Tree Officer Consultation Update

Subject: FW: WA/35/22/HH - Pre-commencement installation of Tree Protection Measures

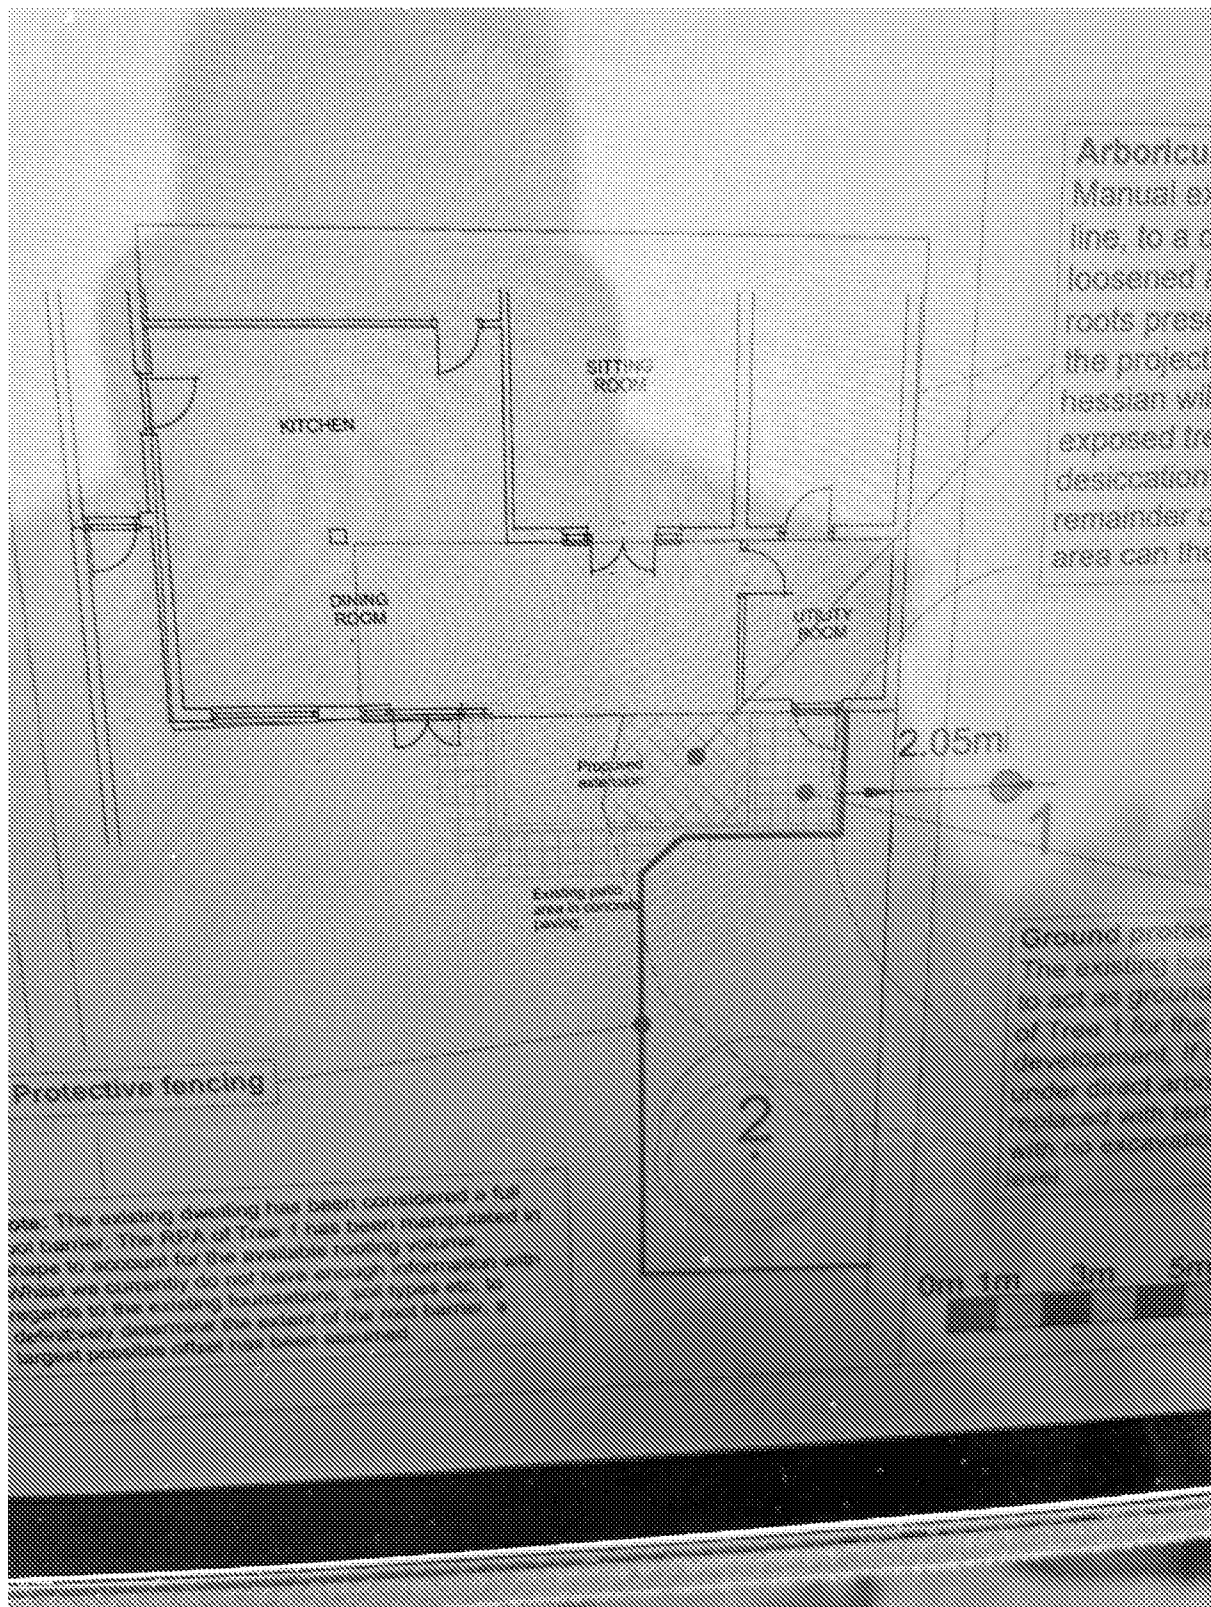
I am pleased to see from the photographs that HERAS panels have been double-clamped and from the inside. As discussed at our recent meeting, the fencing is intended to act as a Construction Exclusion Zone (CEZ).

The following items need to be addressed to my satisfaction before I can recommend that pre-commencement requirements have been met:

1. Due to the impracticality of installing HERAS panels in confined space part of the root protection area (RPA) remains unprotected. You will need to either install ground protection (as described in the arboricultural method statement (AMS)) or as an alternative for this scheme I would be satisfied if some road pins and orange nylon mesh was secured to prevent accidental compaction/contamination.
2. There should be no storage of materials or spoil within the CEZ. Please remove the patio slabs/brick.

Please see photo evidence of the additional red mesh protection and the slabs removed from the area. Please can you confirm this is what you were wanting.

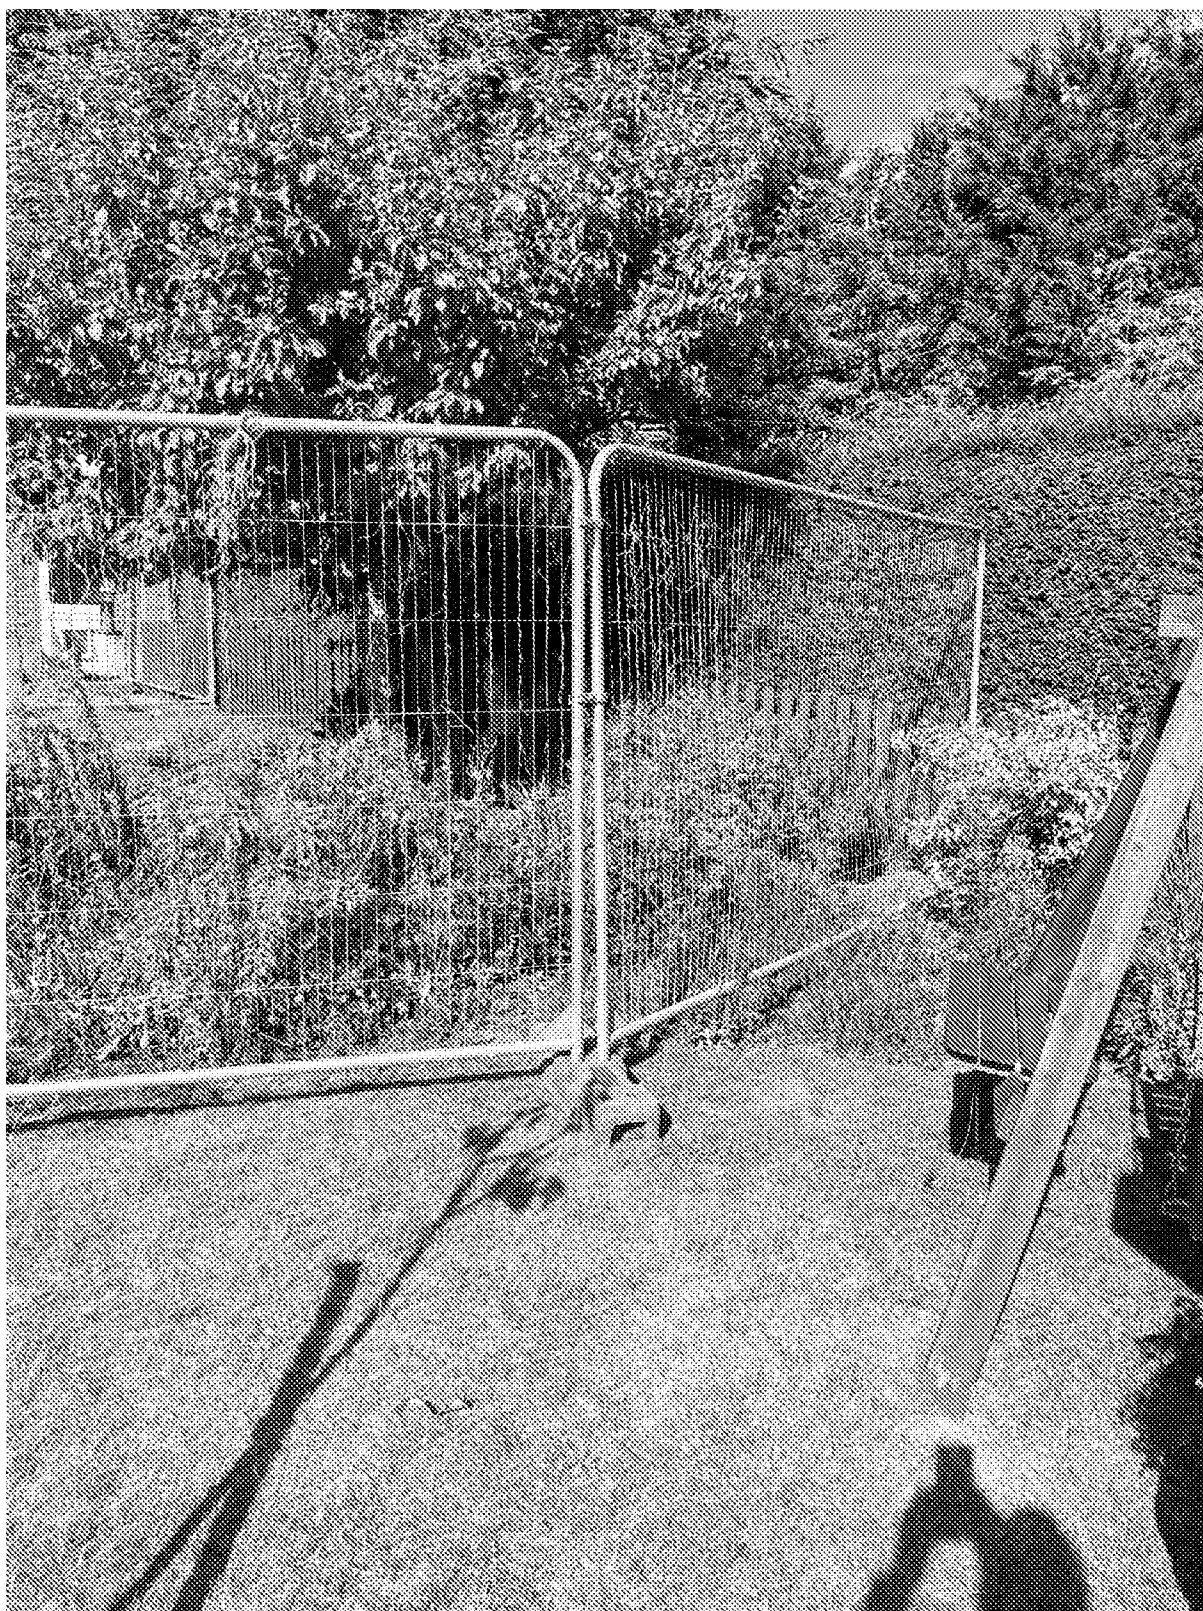
As promised, please see attached photos of the fencing with the double clips.

note: The existing dwelling has been considered a full
barrier. The RPA of Tree 1 has been manipulated in
shape to account for the available rooting volume.
Whilst we currently do not have enough information with
regards to the existing foundations, soil types etc. to
definitively determine the extent of the root barrier, a
largest possible offset has been assumed.
